# MUTCD UPDATE & COMMENT SUBMITTALS

Prepared for PCC, NPA & IPMI May 2021 BY Mary S Smith Copyright Walker Consultants 2021. All Rights Reserved.

This document discusses the proposed changes relative to parking, and suggests comments to be submitted by the parking industry groups and/or parking professionals. We do have a voice and can influence the standards.

#### Sheet 1 of 2:

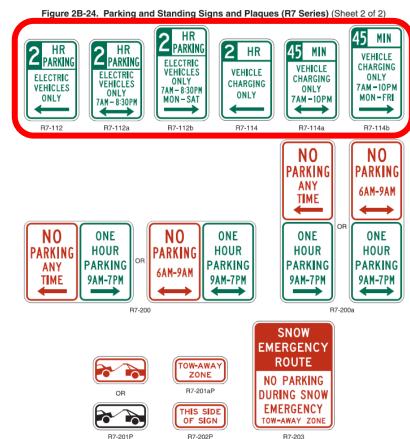
New signs highlighted in red. FHWA chose to eliminate signs showing time limits with the P in a green circle and the words Pay Parking. Note R7-21, 21a 22, 23 and 23a in 2009 and the revised versions in the NPA, especially the change to the term "metered parking". As industry is moving away from meters to pay by phone and other means, it is strongly recommended not to use Metered Parking. NCUTCD is reportedly also recommending use of "Pay Parking", not "Metered Parking."

- New back in and onehour parking signs.
- Two new EV Charging placards in black.
  - Why black? Should be green for consistency with accessible parking and new EV charging signs on sheet 2 of 2.

- Sheet 1 of 2:
  - New R7-113aP and R7-113bP: Recommend that these be put with the remaining R7-113 series signs on sheet 2 of 2, and that the color be green not black, for consistency with other parking regulation signs, such as the R7-8 accessible parking sign.

- R7-21 and R7-22: As the industry that actually administers on-street parking, we strongly recommend keeping the term Pay Parking that was used on the 2009 R7-21 and 22 signs, rather than "metered parking". The industry is moving away from meters and agencies are eliminating meters altogether and going to 100% pay by phone. The placard R7-21 P is needed, but is not adequate as the only sign, if there is no meter. We understand the NCUTCD is also recommending use of Pay Parking rather than "Metered."

#### Sheet 2 of 2

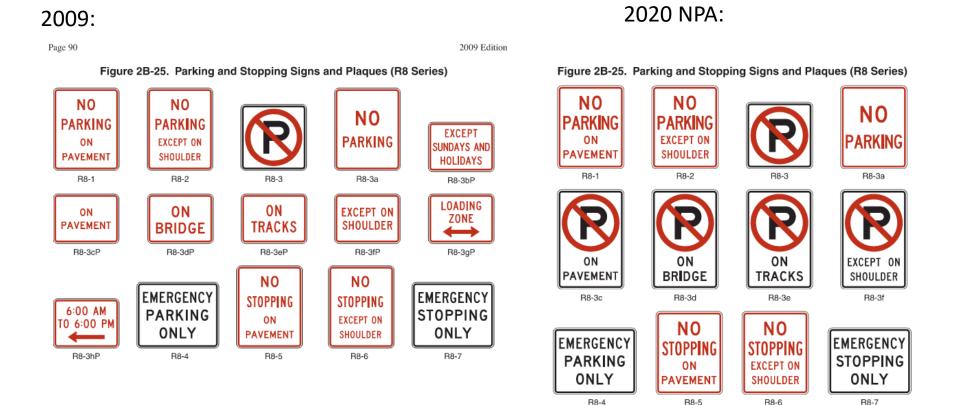
- Whole new row of EV charging stall signs
  - No symbol. NCUTCD recommends symbol as does Walker.
  - Note philosophy of time limits is possibly only to reflect general regulation of on-street parking to two hours or 45 minutes and not necessarily to make people move car after specific time period. But need signs usable for overnight parking for residents and where employees are allowed to park.

Move EV plaques from previous page to locate with EV and use green to go with this series. Use EV charging symbol. Industry is moving towards that symbol for all parking. Add a sign with symbol and words for EV charging that is not time limited, i.e., overnight parking on

- Sheet 2 of 2: R7-112 and 114 series of Electric Vehicle Charging Signs. We strongly recommend use of the EV charging symbol D9-11b on stalls for EV charging. We disagree that the symbol is not easily understood as of 2021 and note that it has been acceptable on Service Signs since 2009. The Access Board recommended use of that symbol in its 2014 US Access Board Technical Guide: Parking, available at <a href="https://www.access-board.gov/files/ada/guides/parking.pdf">https://www.access-board.gov/files/ada/guides/parking.pdf</a>. It is noted that stalls for EV charging have become more common in the last few years, and will likely increase significantly in the next decade. The Biden infrastructure package calls for installing hundreds of thousands of charging units. Now is the time to get the sign for EV charging established. We also need to have guidance for EV charging on streets and SROPT that is not time limited, such as overnight resident or all-day employee parking. Finally there is a need for a sign that indicates both EV and accessible parking as shown below. We suggest the base sign as below with additional placards top and bottom for time limits and the R7-113aP and bP placard signs.

Add Sign D9-XX

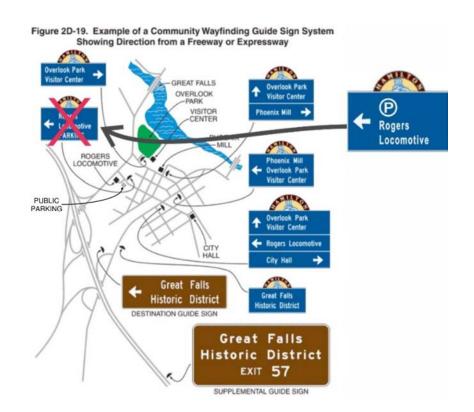
## COMMENT TO BE SUBMITTED: USE BLUE/WHITE P SIGN TO DIRECT AND IDENTIFY PUBLIC PARKING

- The design of the sign would be a white font and circle using an E-modified font with a blue background (pantone 294, within the FHWA blue color box).
   Character of the "P" and circle should follow Standard Highway Signs that already utilize the P symbol
- Proposed text (clean):

12a1 The parking symbol of a white P on a blue background enclosed in a circular white border (sign over all minimum 24 inch) should be used at the entrance of an off-street, publicly accessible parking area.

The Parking (D9-XX) sign (see Figure 2I-1), with accompanying Advanced Turn and Directional Arrow Auxiliary signs, may be installed on approach routes -to show the direction to nearby publicly accessible parking areas. For large-parking areas, the Parking (D9-XX) sign may be supplemented with a parking facility name or logo and may include a changeable message sign element showing the number of available spaces and/or parking fee with a letter height for numeric digits of at least six inches.

Add Plaque D9-XXP Note as Optional

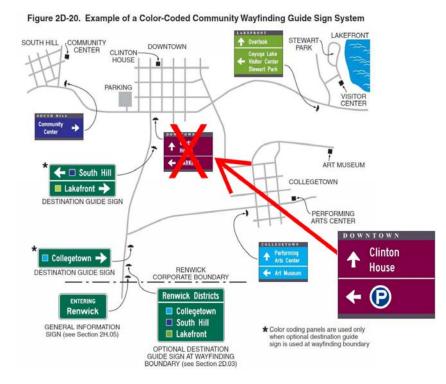
12b The Parking (D9-XX) sign may be supplemented by an educational plaque placed below the D9-XX sign.
